PRO

550cc

Print Area

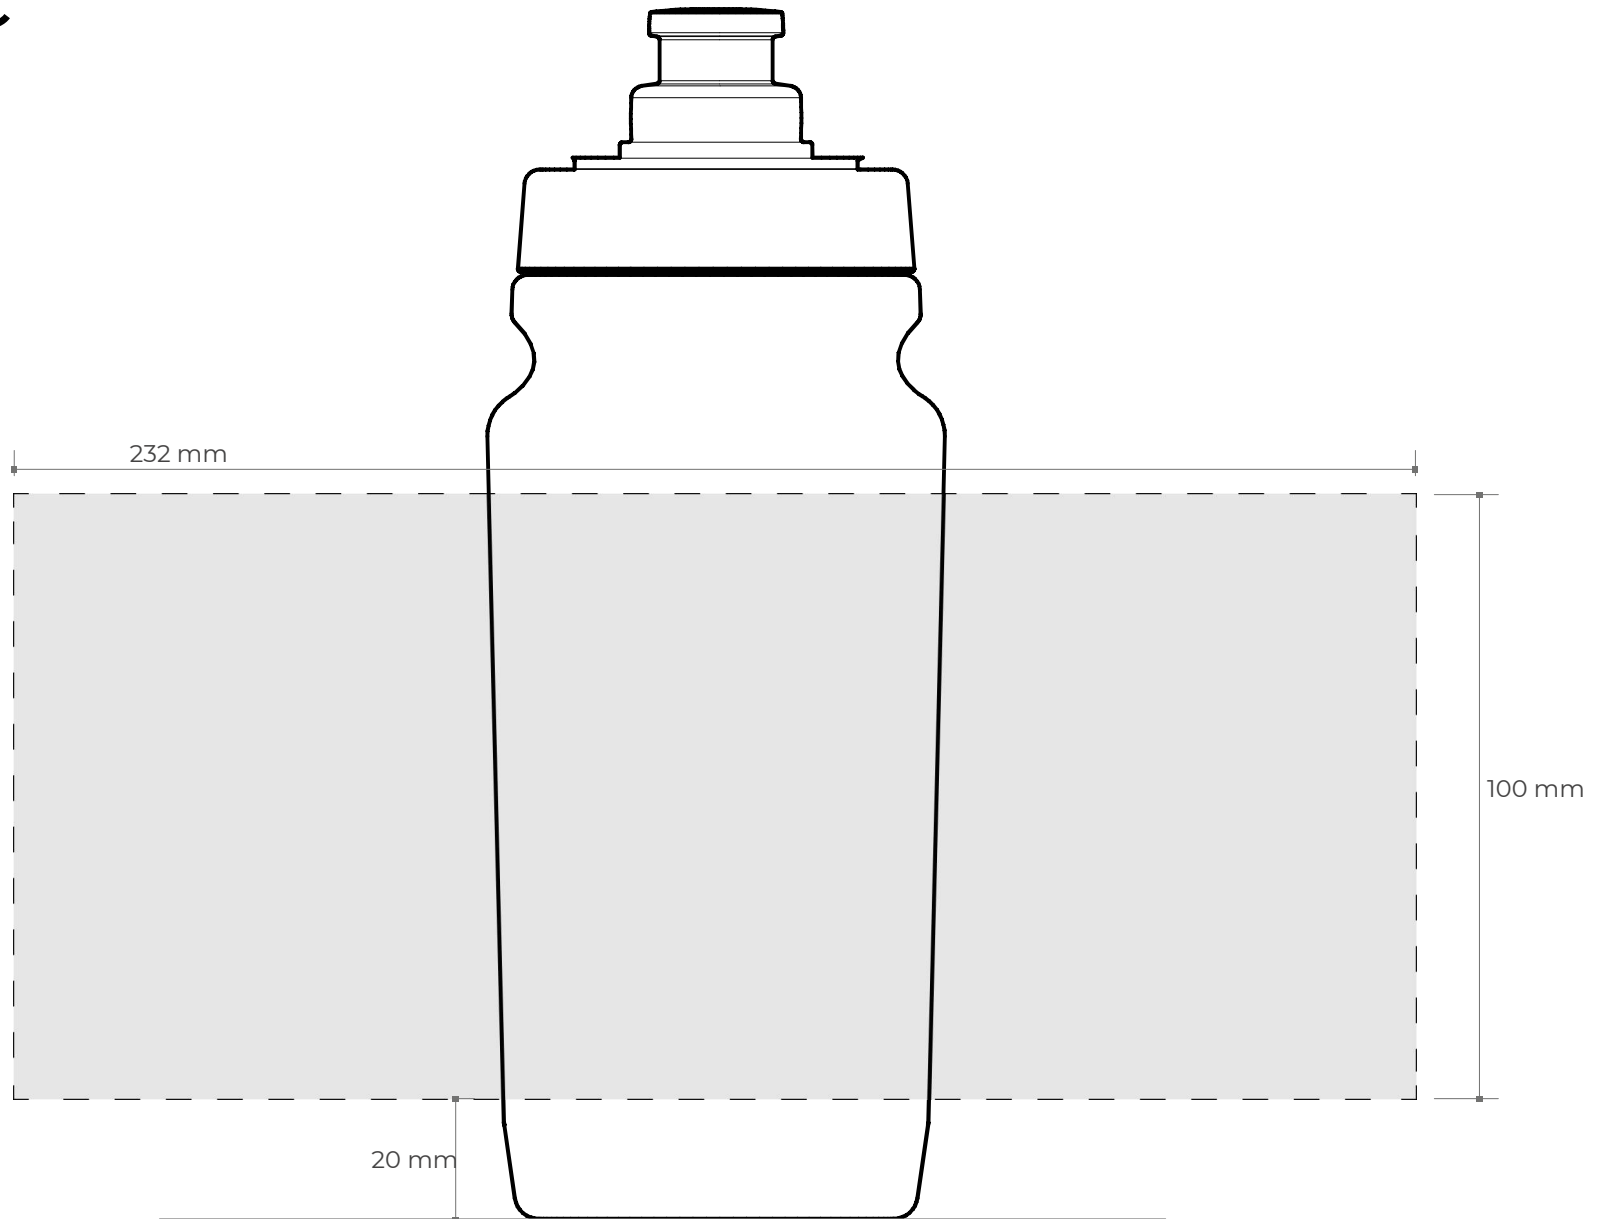
The impression can not close on the circumference of the bottle:
it's necessary to consider a non -printable area (approx. 0,8 cm width)
